# 42 Honeysuckle Drive

State Significant Development (SSD-10378)

DEVELOPMENT MODIFICATIONS

March 2022

## 7.1 Design Changes

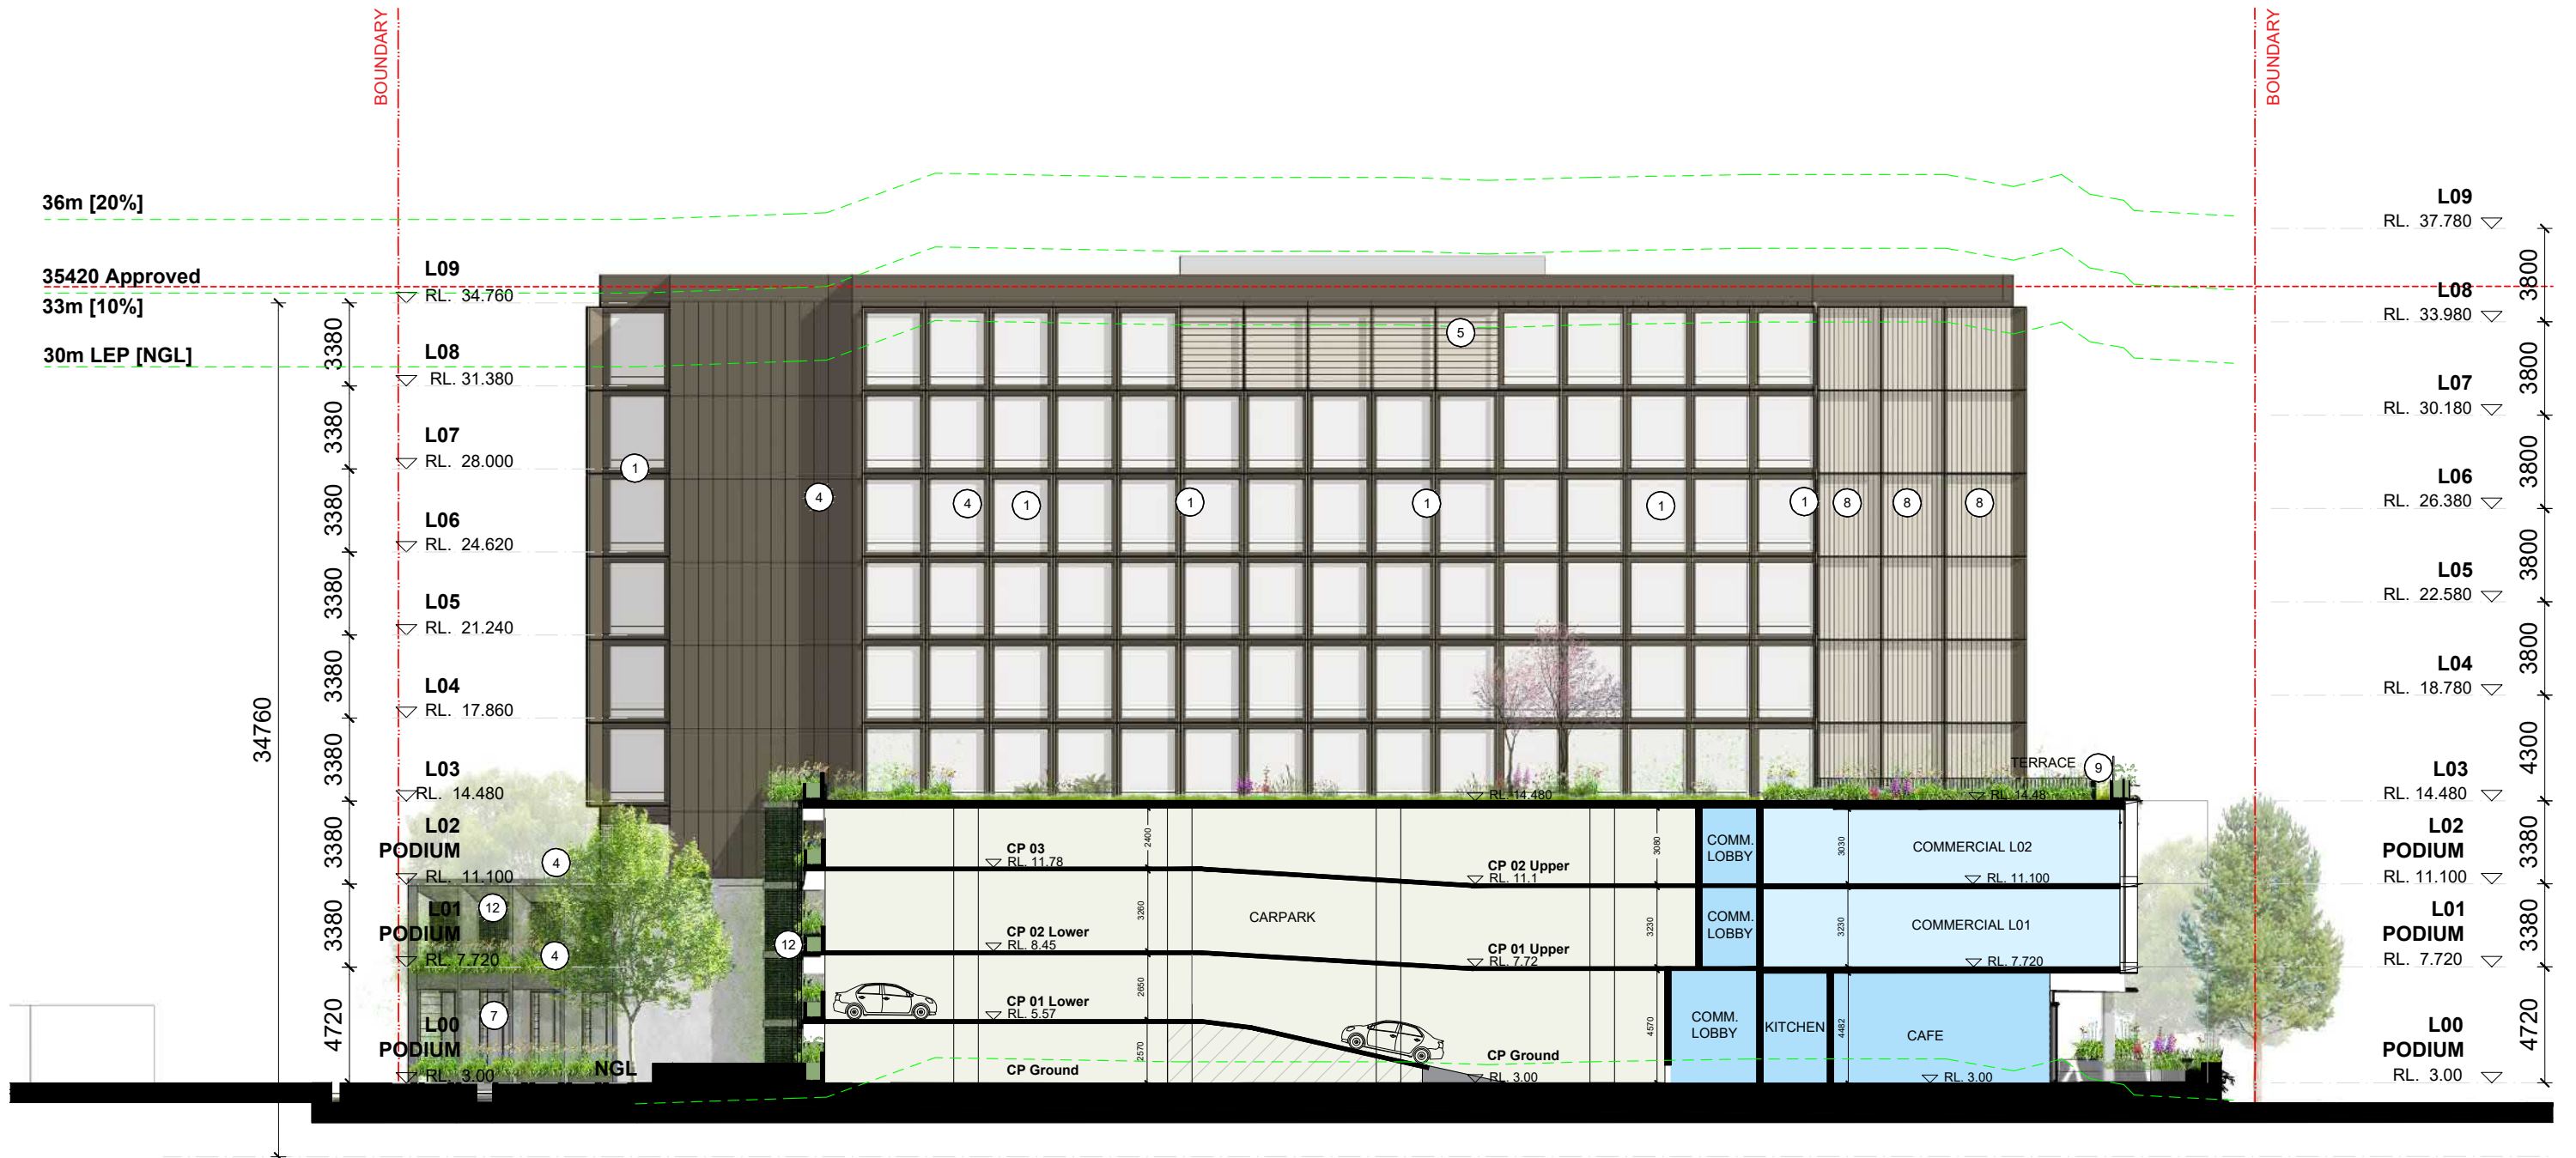
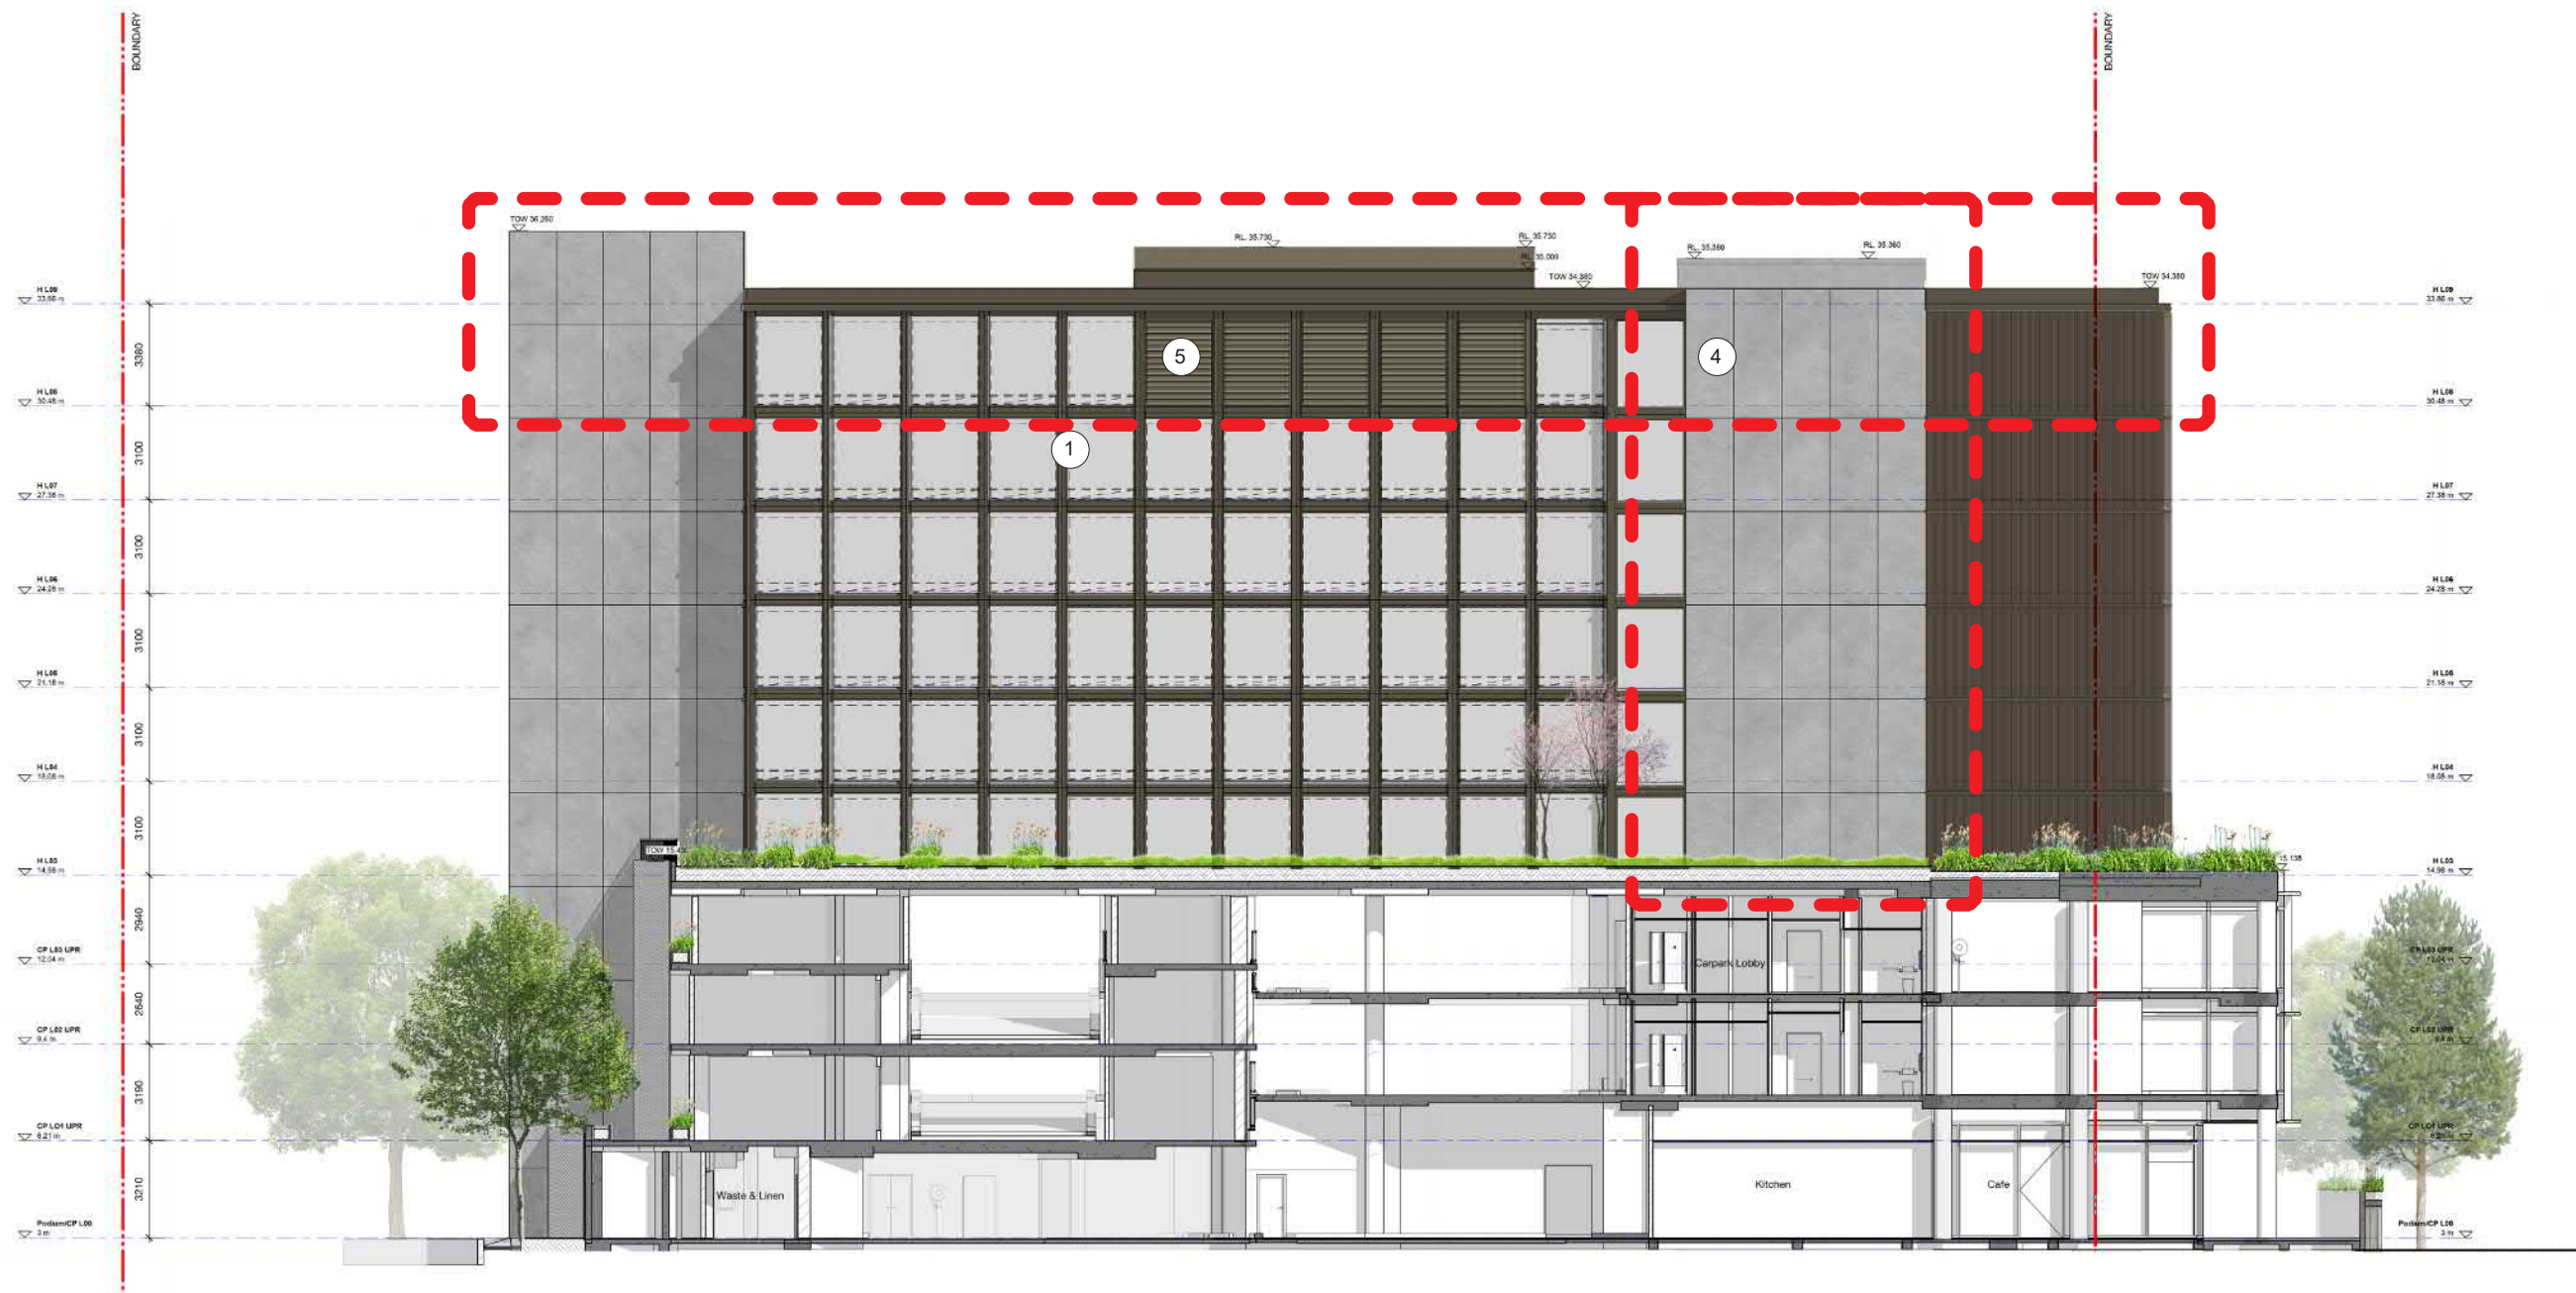
1 / Hotel slab to slab levels reduced from 3380mm down to 3100mm. This has resulted in an overall hotel building height reduction.

2 / Facade amended outside lift lobby. This is now concrete construction rather than glazing to increase privacy between the hotel and commercial tower.

3/ Facade colours and materiality remain the same
